ADDENDUM NO. 4

**Federal Aid Project No. CMQ-003S(201)
Pedestrian Bridge Replacement Br. No. N-22-002 (Steel)
Pauchaug-Schell Bridge Greenway over the Connecticut River**

Transmitting changes to the Contract Documents as follows:

ELECTRIC CONDUIT DETAILS

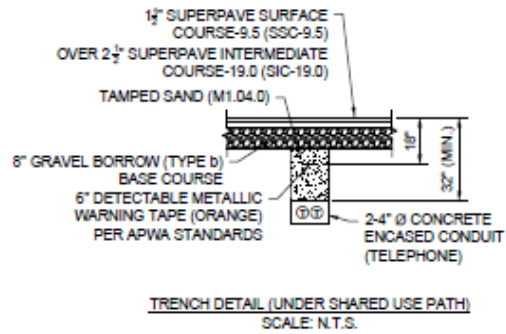
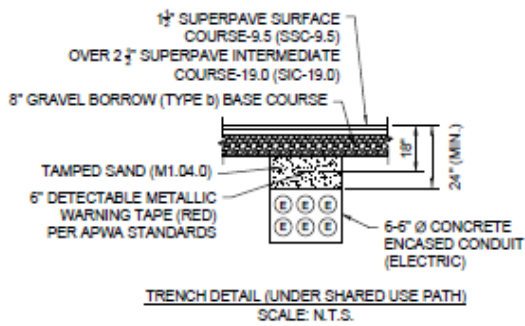
Question 27) Please provide a trench detail for items 804.4 and 804.6. Specifically, detailing trench width and height, and backfill materials (ie. Sand or concrete).

Trench and backfill requirements shall be per the trenching details shown below.

Response 27) See revised special provisions for Item 804.4 and 804.6 on pages A00801-185 and 186.
